DKA Architecture
Access Design Assessment Report

Old Byron Bay Hospital Repurpose
Cnr Wordsworth and Shirley Street
Byron Bay NSW 2481

Project: Old Byron Bay Hospital Repurpose
 Document Type: Access Design Assessment Report
 Our Reference: P221_011-4 (ACCESS) KG

Figure 1 – Pedestrian Entries

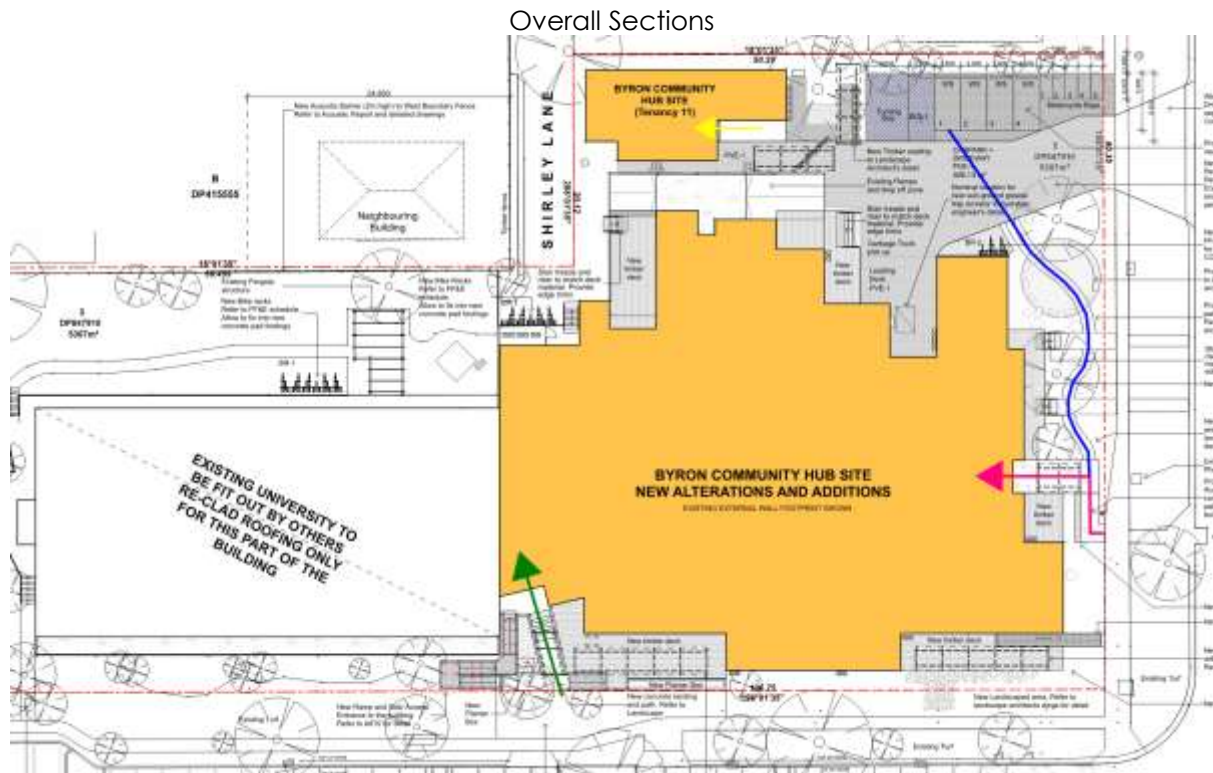
An accessway to main building from the site boundary on Shirley Street is provided via a 1:21 walkway shown in **pink** and from the site boundary on Wordsworth Street via a stairway and 1:14 ramps shown in **green**. An accessway to Tenancy 11 is provided via the driveway and

accessway from site boundary on Shirley Street shown in **yellow**. Additional accessway is proposed via accessible parking area shown in **blue**.

Except for Tenancy 8 and 11, additional entrances proposed via terraces and external areas are assessed as secondary entries.
